Device **C164CI-8E**
Marking/Step **Step ES-CB, CB**
Package **C-MQFP, P-MQFP-80**

This Errata Sheet describes the deviations from the current user documentation.

Figure 1 Additional Jitter

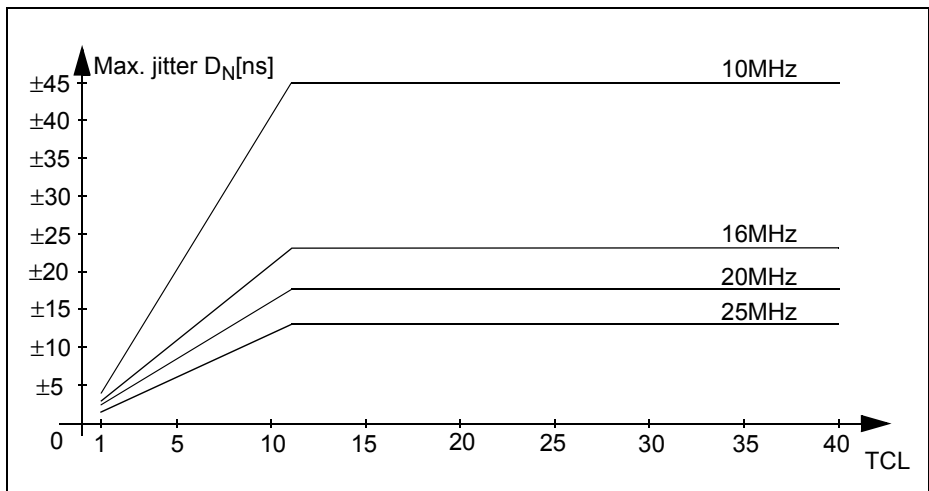
New value of the additional jitter

For an accumulated period of $N \cdot \text{TCL}$ the new maximum jitter $D_N[\text{ns}]$, which exceeds the specified value in the Data Sheet, is computed using the formula:

$$D_N[\text{ns}] = \pm[(50 / f_{\text{CPU}} + 164 / f_{\text{CPU}}^2 - 0.04) * (N / 2 - 1) + 1180 / f_{\text{CPU}}^2 + 0.2]$$

Where N = number of consecutive TCL, f_{CPU} = CPU frequency in MHz.

This approximated formula is valid for $1 \leq N \leq 12$ and $10 \text{ MHz} \leq f_{\text{CPU}} \leq 25 \text{ MHz}$.

For all accumulated periods longer than 12 TCL the $N=12$ value can be used; see figure below.

In case that the additional jitter causes problems in the system which cannot be relaxed with software adapted timing parameters, then direct drive or prescaler mode can be used. If the maximum frequency of the on-chip oscillator (16 MHz) is not sufficient then an external clock generator can be used.

Figure 2 SSCTB Timing

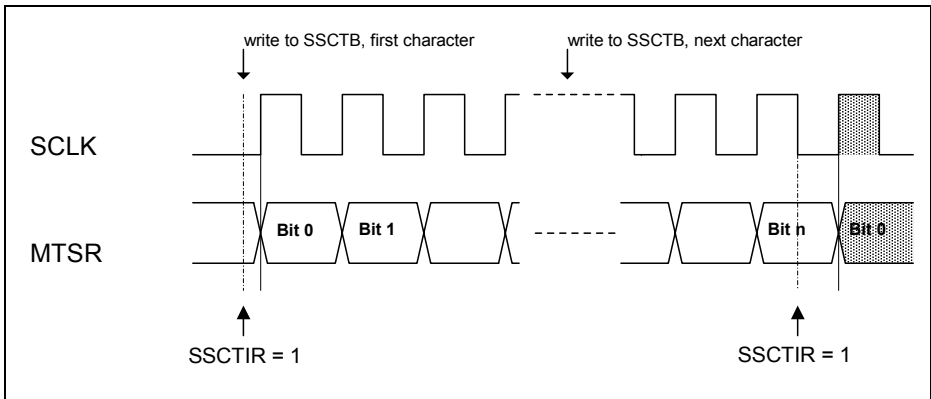
In master mode, the timing of SSCTIR is as follows:

When SSCTB has been written while the transmit shift register was empty (and the SSC is enabled), flag SSCTIR is set to '1' directly after completion of the write operation, independent of the selected baud rate. When the transmit shift register is not empty when SSCTB was written, SSCTIR is set to '1' after the last latching edge of SCLK (= 1/2 bit time before the first shifting edge of the next character). See also e.g. C167CR User's Manual V3.1, p. 12-5.

The following diagram shows these relations in an example for a data transfer in master mode with SSCPO = 0 and SSCPH = 0. It is assumed that the transmit shift register is empty at the time the first character is written to SSCTB:

Typically, in interrupt driven systems, no problems are expected from the modified timing of flag SSCTIR. However, when flag SSCTIR is polled by software in combination with other flags which are set/cleared at the end or at the beginning of a transfer (e.g. SSCBSY), the modified timing may have an effect.

In order to achieve a defined and systematic behavior with all device steps, the SSC receive interrupt, which is generated at the end of a character transmission, may be used instead of the SSC transmit interrupt.

Figure 3 Structure of Output Driver with Edge Control

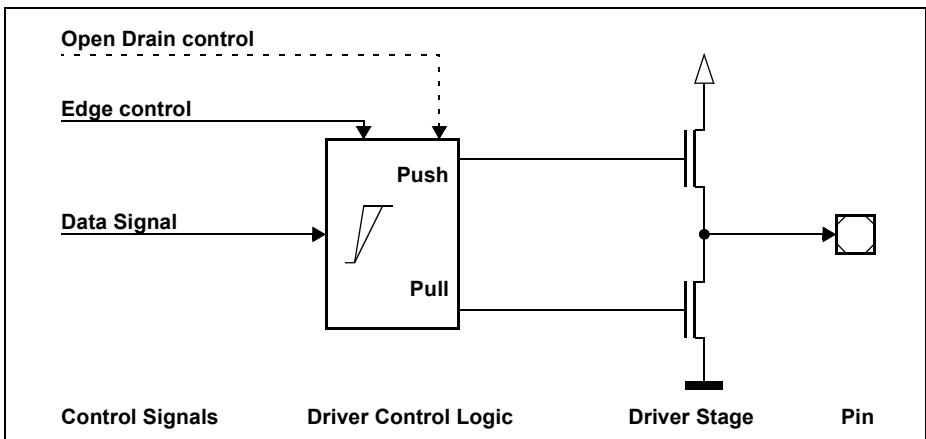
PORT.D2 Output Driver Control

This defines the rise/fall time for the respective output, i.e. the output transition time. Slow edges reduce the peak currents that are drawn when changing the voltage level of an external capacitive load. For a bus interface, however, fast edges may still be required. Edge characteristic effects the pre-driver which controls the final output driver stage.
